# DUNE-APA PCB Tolerance Change Request

DUNE APA Technical Board Meeting, 21st August 2023.

## Geometry Board Tolerances And Metrology Procedure Change Request

Requester: Justin Evans, Vitaly Kudryavtsev, Graham Miller, Pawel Guzowski & Anthony Ezeribe	Date: 31/03/2023
	Number: APA-PCB-09

# Wrap Board Tongue & Shoulder Heights

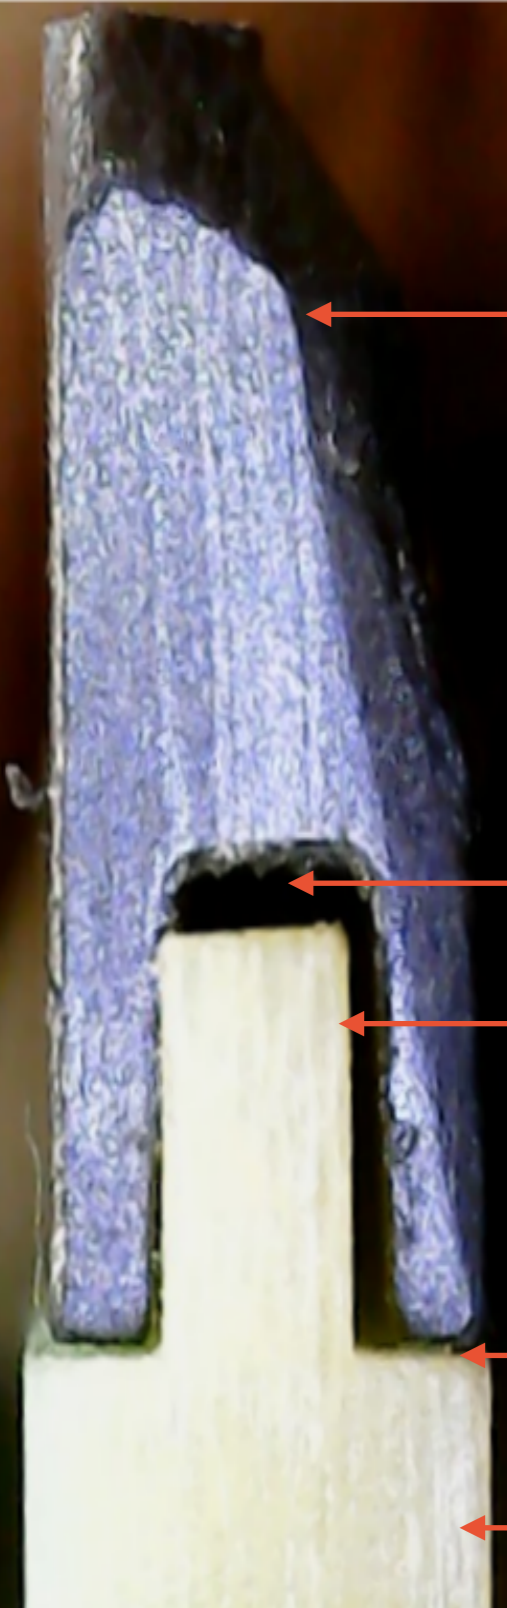
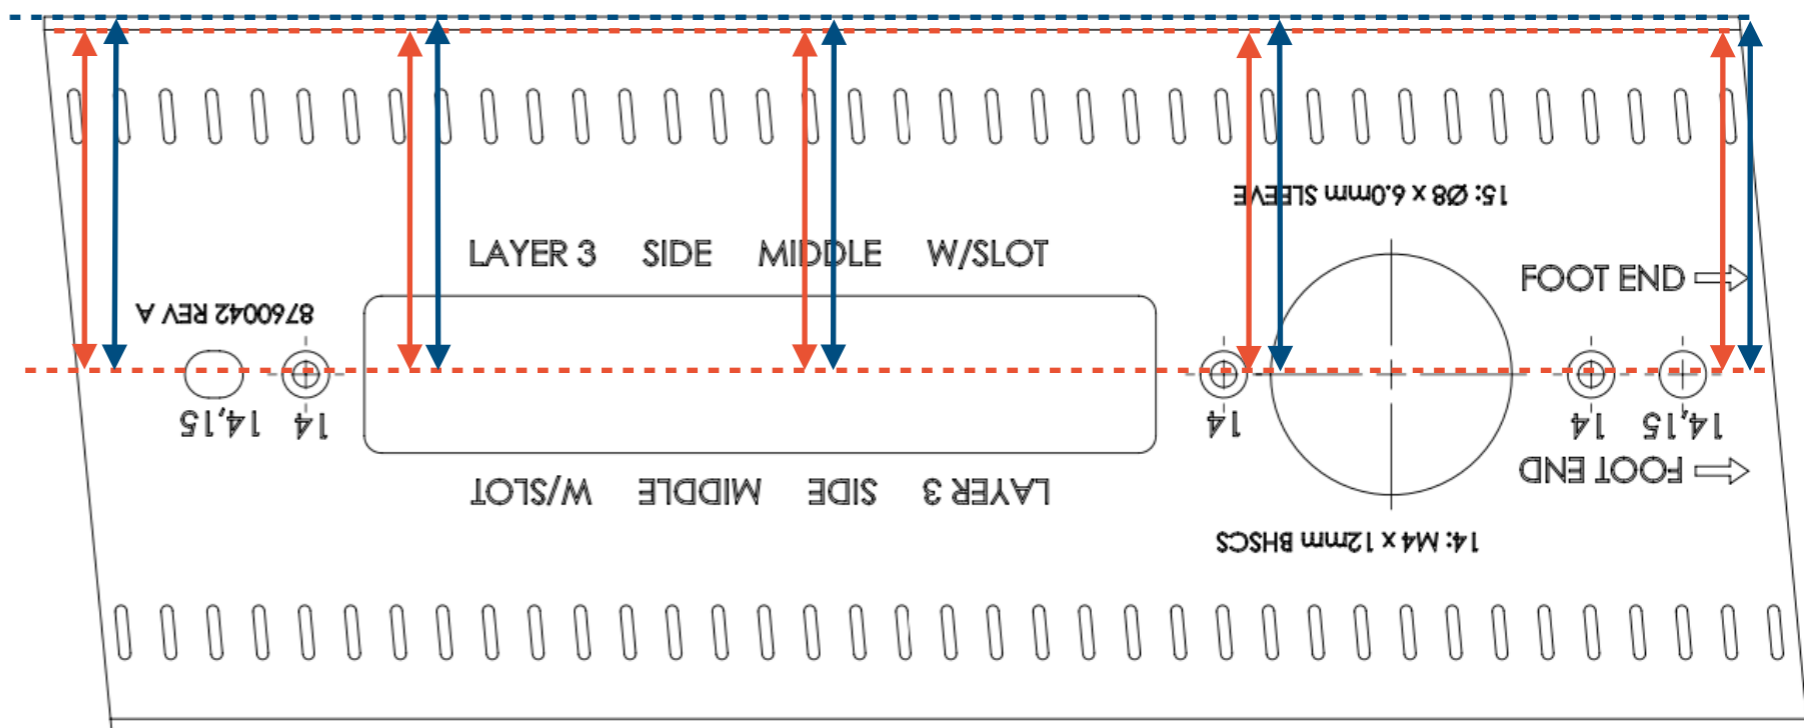
- Tongue and shoulder heights are currently measured from the edges of a given wrap boards resulting in 2 data points.
- The proposal is to increase the measurement points from 2 to 5 and then base the decision on the average of the the 5 data points.

Currently we measure the wrap board tongue/shoulder heights from the edge side of a given wrap board. The tongue height is the distance between a wrap board shoulder and the top end of the wrap board tongue while the shoulder height is the distance between the board datum line and the base of the tongue. To ensure that good wrap boards with a negligible dip (for instance) on the edge side of the tongues or shoulder heights are not rejected in QA, we propose to increase the tongue/shoulder height measurement points from the current 2 to 5. This way, we can average the tongue height results from the 5 measurement points to

If the current procedure calls for measuring two points and by doing so "good" boards are rejected (non-conformance)... measuring five points and taking an average brings them back into conformance?  
The change cannot be made because this is not how inspection is done. For example, if the tongue is 1mm thin on one end and 1mm thick on the other end the average thickness is within tolerance (which gives an erroneous result).

- The comment seem to consider tongue thicknesses.
- The request was for tongue/shoulder **heights** only.
- Point failures were considered by the team but we thought that point failures that are in spec when averaged should not affect the strength of an epoxied tooth-strip.

## (2) Board Widths:

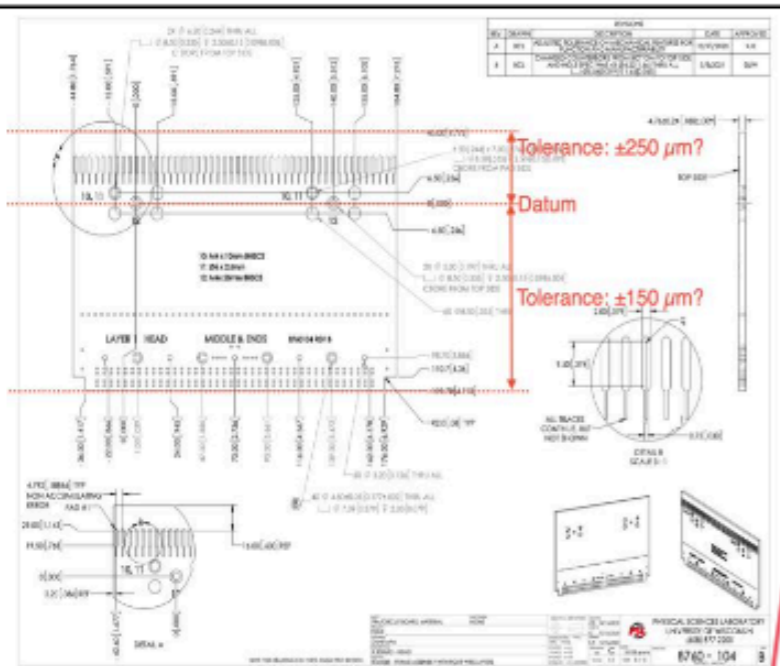
Tolerance on the board widths is currently  $\pm 150 \mu\text{m}$ . We are proposing to change the tolerance of the datum to solder pad head board edge widths to  $\pm 250 \mu\text{m}$  while the datum to Mill-Max pin hole edge widths remains unchanged at  $\pm 150 \mu\text{m}$ , see the picture below for details.

The distance between solder pads and width-edge of head boards is currently 13 -15 mm so removing or adding an extra  $\pm 250 \mu\text{m}$  will not affect the functioning or IPC power ratings of the head boards. So we propose to move the tolerance of the datum to solder pad head board edge widths from the current  $\pm 150 \mu\text{m}$  to  $\pm 250 \mu\text{m}$ .

The edge closest to the solder pads does not affect form, fit or function. The request is okay.

Approved.
